UNITED STATES PATENT AND TRADEMARK OFFICE

APPLICATION NO.	FILING DATE	FIRST NAMED INVENTOR	ATTORNEY DOCKET NO.	CONFIRMATION NO.
10/596,847	06/27/2006	Jasko Musacfendic	AP099-06	1292

Office Action Summary	Application No. 10/596,847	Applicant(s) MUSAEFENDIC, JASKO	
	Examiner JENNIFER STEELE	Art Unit 1794

DETAILED ACTION

FIG. 1

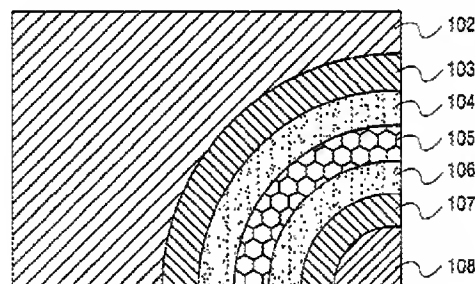
- e. A polymer matrix in between said first and second layers, and said first and second plies.
3. Neal teaches a panel configuration composite armor (Title). Neal teaches combining ballistic and fragment resistant fabrics in multiple layers with a central geometrically shaped composite core in a resin which forms a composite panel (ABST). Neal teaches composite panel is designed to withstand impact and can elastically deform to absorb and attenuate energy of a forced attack (ABST). As shown in Fig. 1 below, Neal teaches first and second outer layers, **102** and **108** and at least two inner

plies placed between the outer layers. The inner plies of Neal are layers **103**, **104**, **106** and **107** (col. 6, 7 and 8 describe the layers). Neal teaches a geometric core layer **105** between the inner plies that provides strength and flexibility and is capable of flexing to allow the distribution and dissipation of energy of the attack by a sharp or blunt object (col. 7, lines 17-41). The geometric core of Neal is equated with a dissipating element between the inner plies. Neal teaches the layers are suffused with a resin and this structure is equated with a polymer matrix in between the first and second layers and the first and second plies.

Regarding claim 62, Neal teaches additional layers, such as layer **104** and **106** in addition to inner layers **103** and **107**.

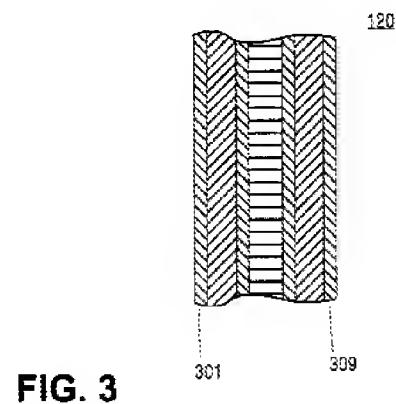
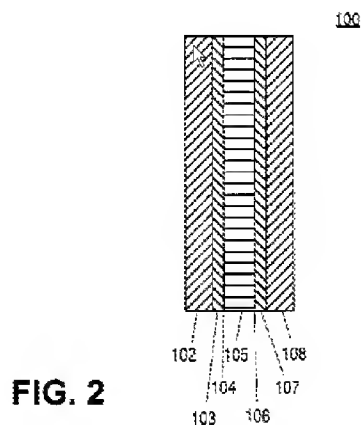
With regards to claim 67, Neal teaches a core of geometric dissipating elements referred to as cells and teaches a plurality of cells. A plurality of cells is at least two dissipating ply elements. Neal teaches the cells are arranged to be closely packed and from the description and Fig. 1 the cells appear to be arranged symmetrically and balanced.

As to claim 70, Neal teaches additional layers **301** and **309** (shown in Fig. 3 below) can be applied on the outside of the composite armor panel and can be comprised of a single ply of fiberglass ballistic grade textile fabric and may have 35-44 % phenolic resin and may have a layer of gelcote applied to the surface (col. 9, lines 8-14). Fig. 2 represents the composite structure of Fig. 1 and Fig. 3 the composite structure with additional layers on the outer layer. A phenolic resin layer is a layer made from a material selected from the group consisting of plastic or polymer.
